CRIME IMPACT STATEMENT

FORMER A-PLANT SITE, HOLLINS BROOK WAY, BURY
JD SPORTS CAMPUS HUB (TOTALLING 7,695sqm.)

FOR: JD Sports Fashion plc

REFERENCE: 2012/0008/CIS/01

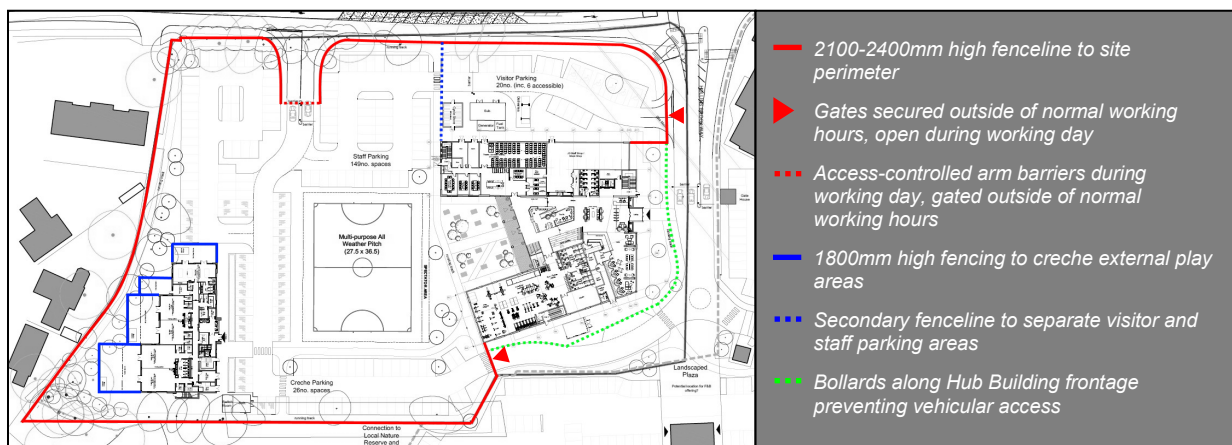
- 3.3.1 The perimeter of the site should be enclosed with secure fencing to prevent unauthorised access, both during the day and outside of normal working hours (see illustration below and Section 4.6 for more information). The gatehouse adjacent to the access-controlled barriers on Hollins Brook Way should be staffed at all times – to control and monitor all access to and egress from the site. It is preferable for all access/egress to be via this staffed entry point. If the secondary access/egress point is required off Pilsworth Lane, it should be secured with access-controlled vehicle arm barriers (controlled by staff card/fob only) during the day and should be secured with gates outside of normal working hours (e.g. 6pm to 6am) - preventing pedestrian as well as vehicular access and meaning all site access/egress is via the security gatehouse out-of-hours.

- 3.3.2 Access to the visitor car park will be before the security barriers, off Hollins Brook Way. There should be a secondary fenceline between the visitor and staff parking areas to deter access between the two areas and funnel all visitors to the main entrance of the Hub building (again, see illustration below and Section 4.6). Outside of normal working hours/at night, the visitor car park should be secured with manual gates, preventing unauthorised access.

- 3.3.3 The existing open land/public right of way route to the south of the site could provide the means for offenders to gain access to and escape from the site without being noticed. It is highly recommended that the site is fully secured with vehicular gates out-of-house, to the south of the Hub building (see illustration above), to ensure that no one can bypass the staffed gatehouse on Hollins Brook Way when levels of activity/surveillance are likely to be lower. Should out-of-hours access be required, the gates should be operable remotely by gatehouse security staff and by staff card/fob. The eastern and southern frontages of the Hub building should be protected by anti-ram bollards to ensure the barriers on Hollins Brook Way cannot be bypassed and ensure the facades of the building outside of the secure perimeter fencing are protected.

- 3.3.7 The external play areas for the creche should be securely enclosed to prevent unauthorised access, both during hours of operation and out-of-hours (see illustration above & Section 4.6 for more information). Any immediately adjacent existing trees or branches should also be removed or pruned where necessary to ensure they do not form a climbing aid over the boundaries.
